NEW ELEMENTARY AND MIDDLE SCHOOL

CONTENTS - VOLUME TWO

phase	Bid Package No. 2
date	January 3, 2008
ADD	October 17, 2007
ADD	October 26, 2007
ADD	November 2, 2007
ADD	November 5, 2007

project # 06022

POWER PLAN - SECTOR "E"
E3.7 SCALE: 1/8" = 1'-0"

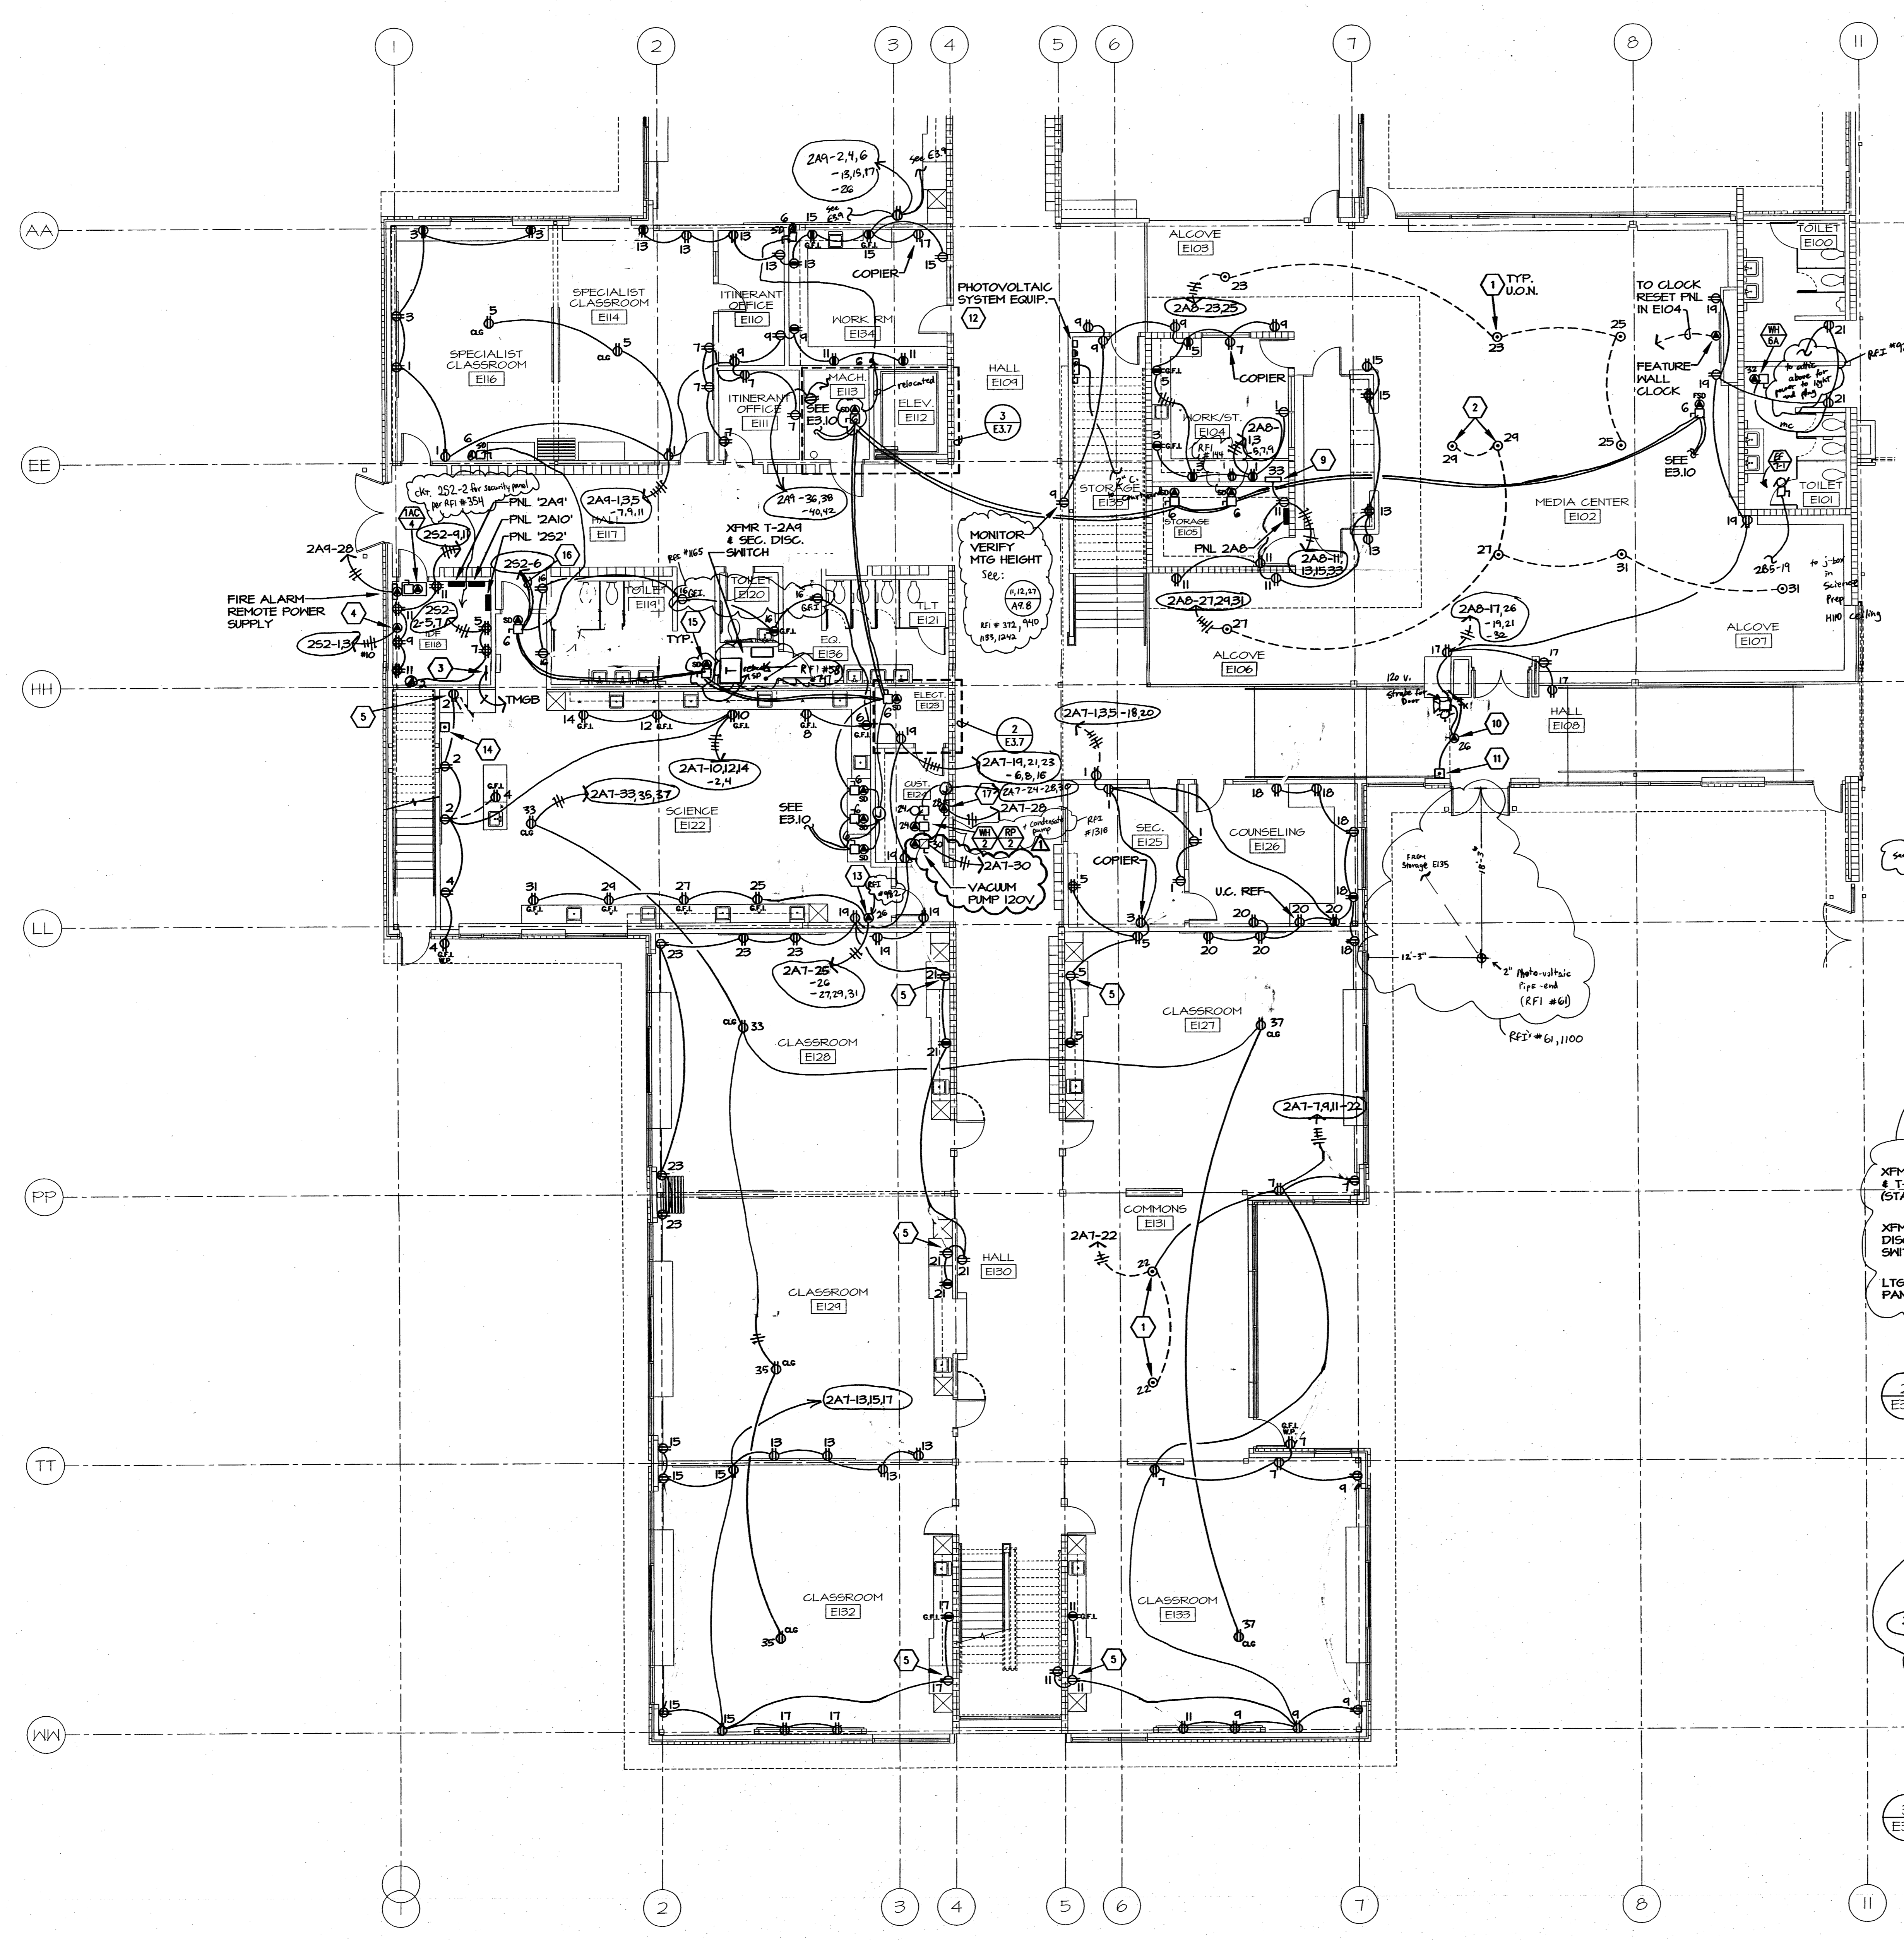
- PROVIDE 30A, 208V, 1ph CONNECTION FOR UPS. MOUNT AT 102" AFF. COORDINATE WITH DIV. IT. (Cap off for future use per R12 2/02)
 - RECEPTACLE LOCATED IN CABINET FOR AV EQUIPMENT. VERIFY MTG HEIGHT.

1 FLOOR PLAN - SECTOR "F"
 E3.8 SCALE: 1/8" = 1'-0"

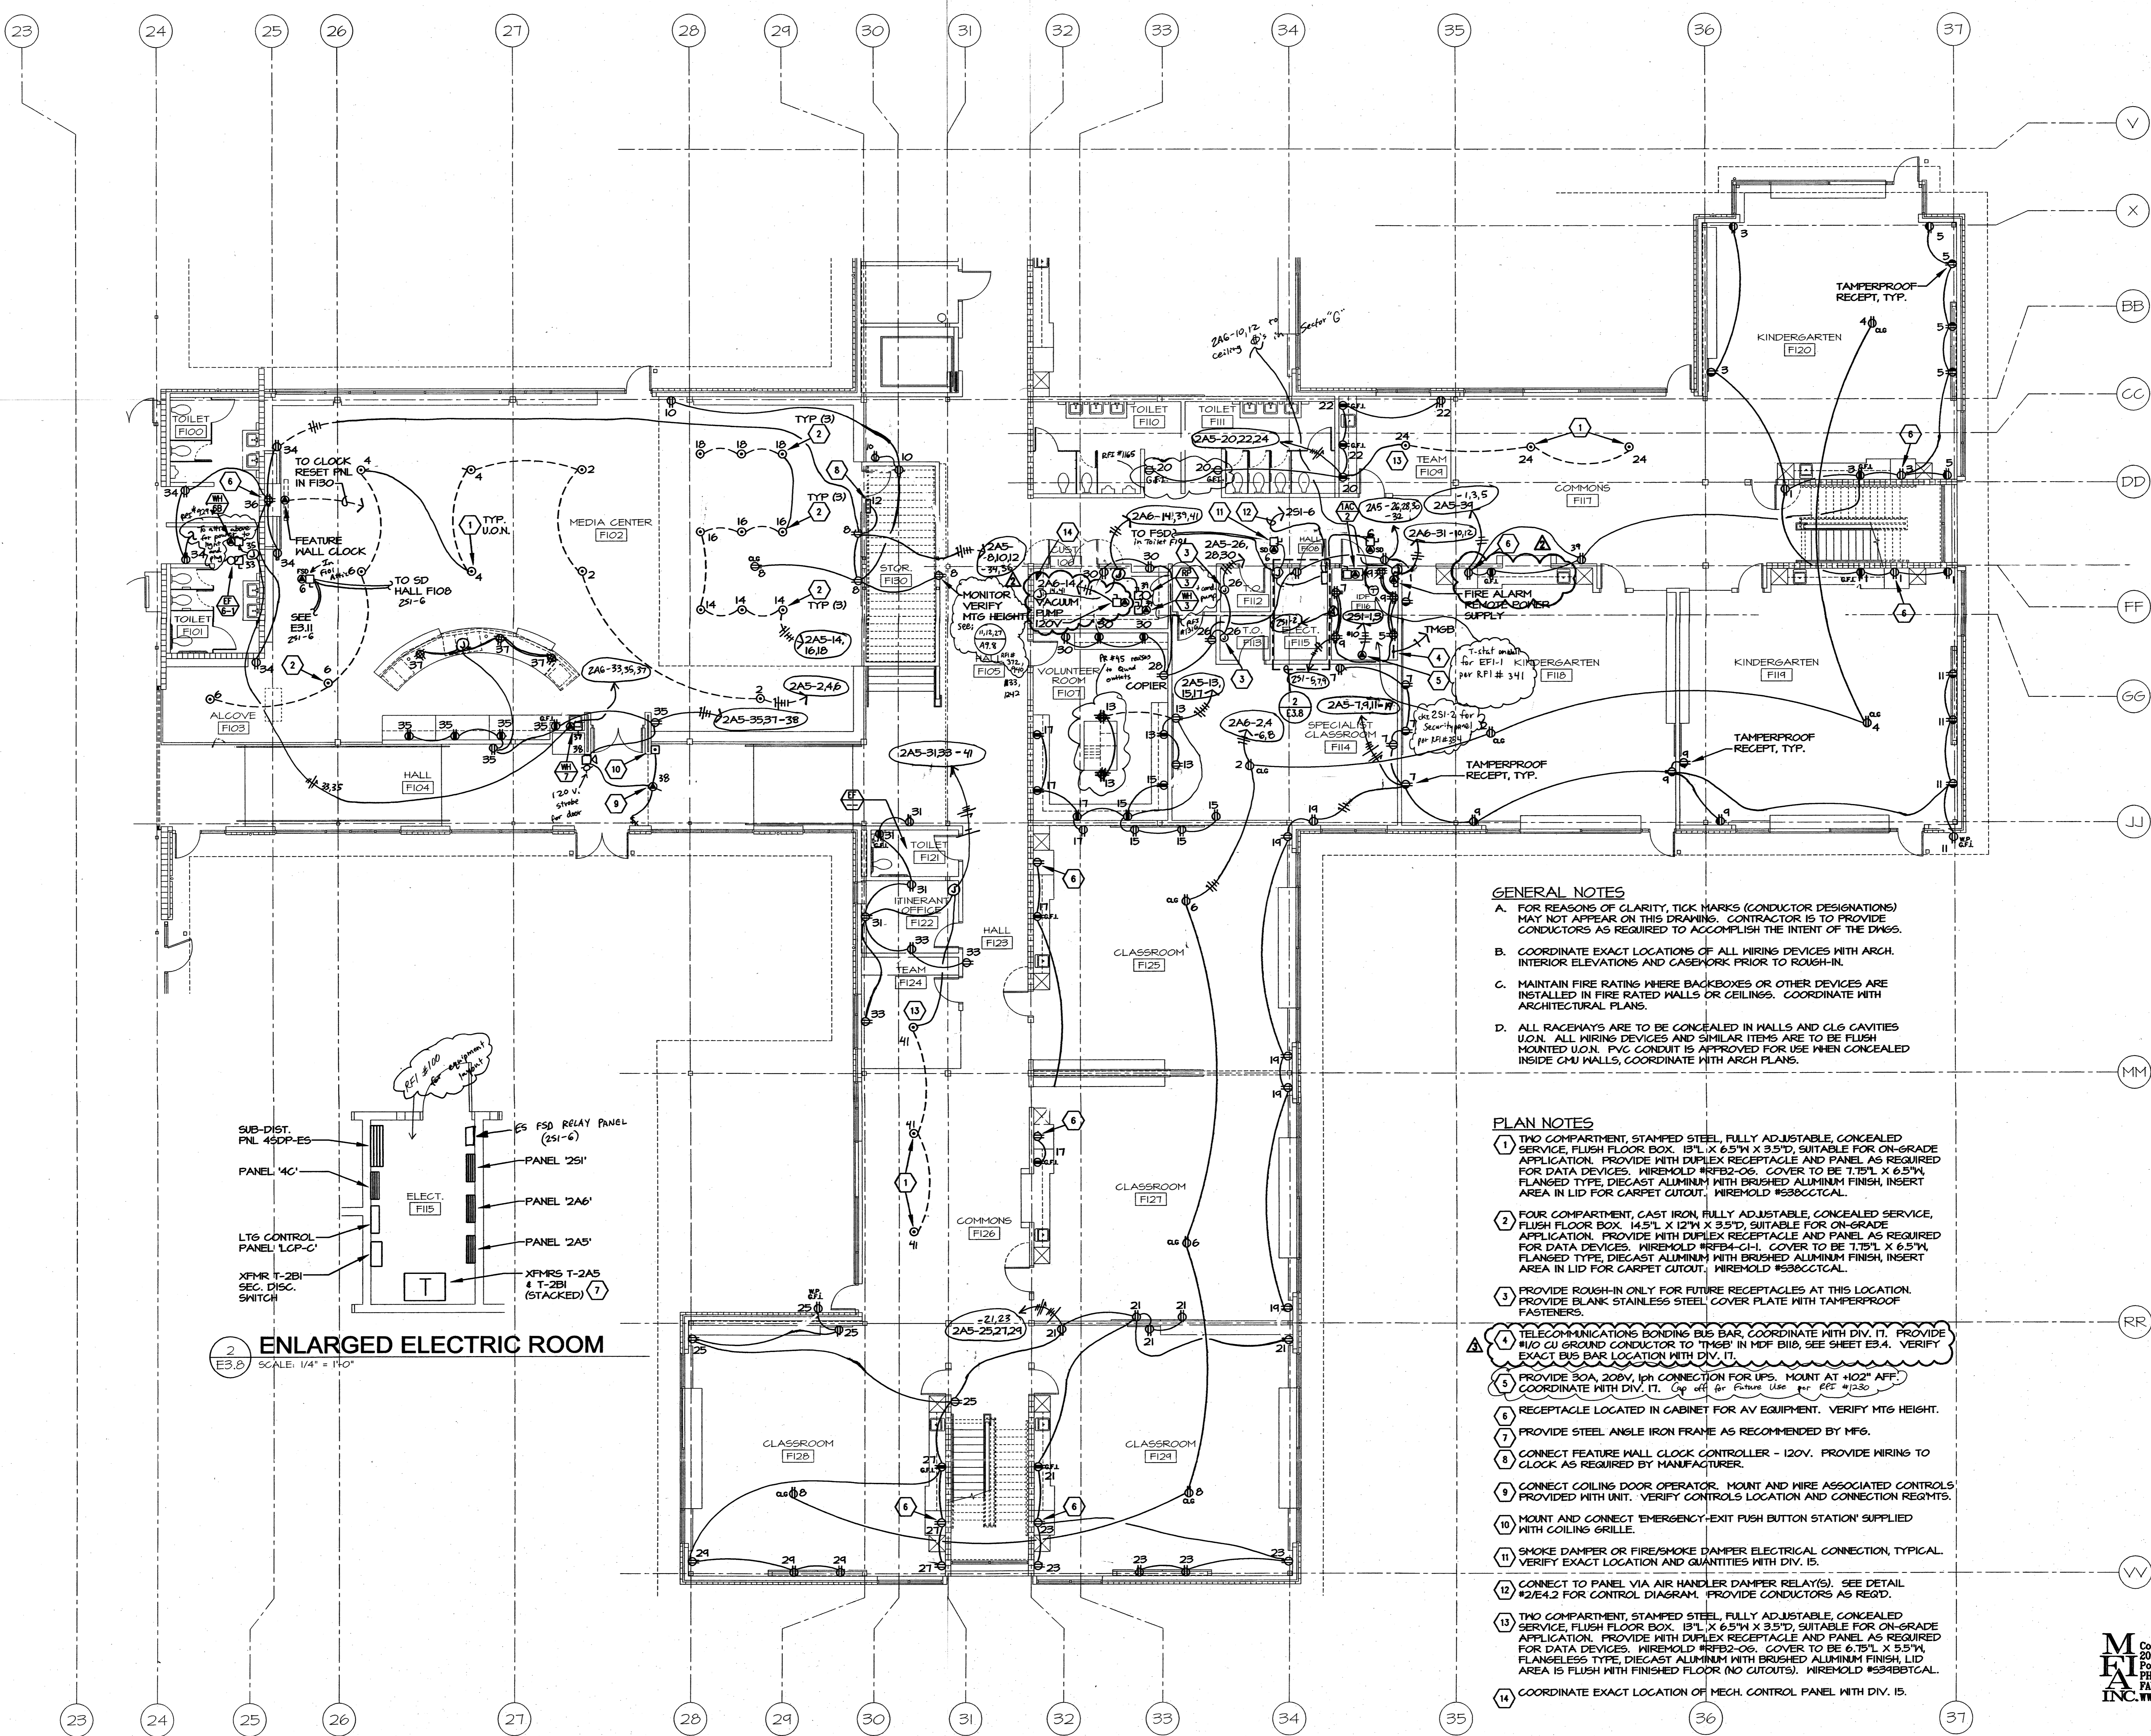
- PROVIDE 30A, 208V, 1ph CONNECTION FOR UPS. MOUNT AT #02" AFF. COORDINATE WITH DIV. IT. Cap off for Future Use per EEP #1230.
 - RECEPTACLE LOCATED IN CABINET FOR AV EQUIPMENT. VERIFY MTG HEIGHT.

SIGNAL PLAN ROOF
SCALE: 1"=20'

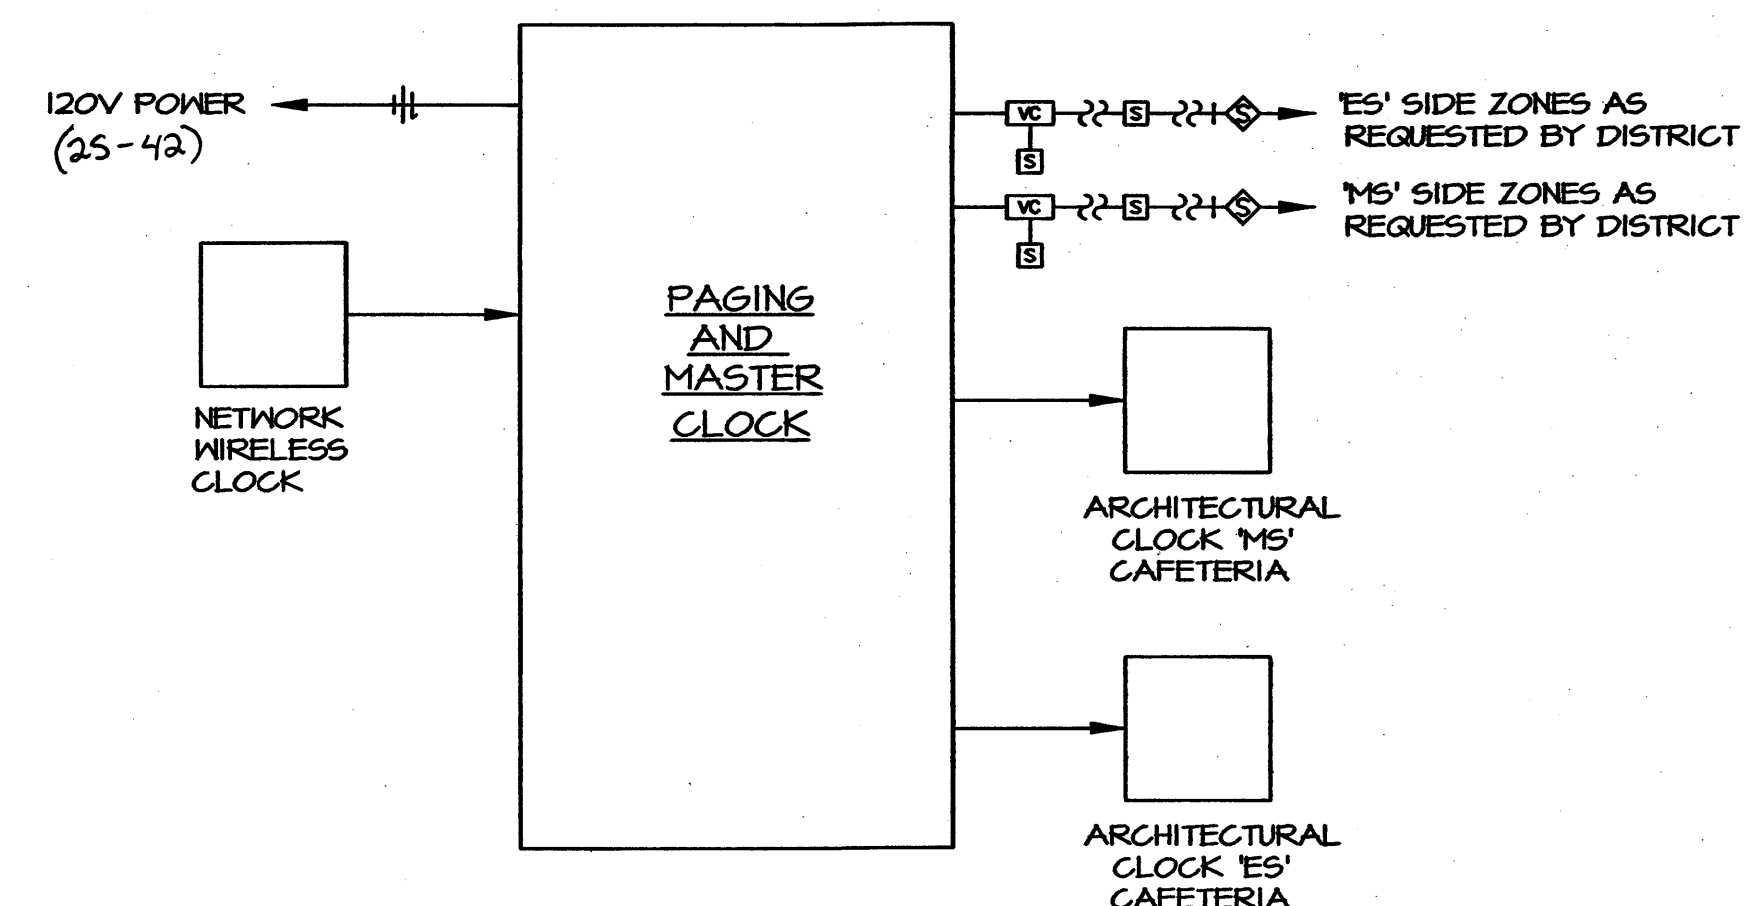
- 1 Provide 2" C. through roof w/ gable neck for Ham Radio antenna cable. Seal conduit opening after cable has been installed. Verify exact location w/ Arch. Plans.
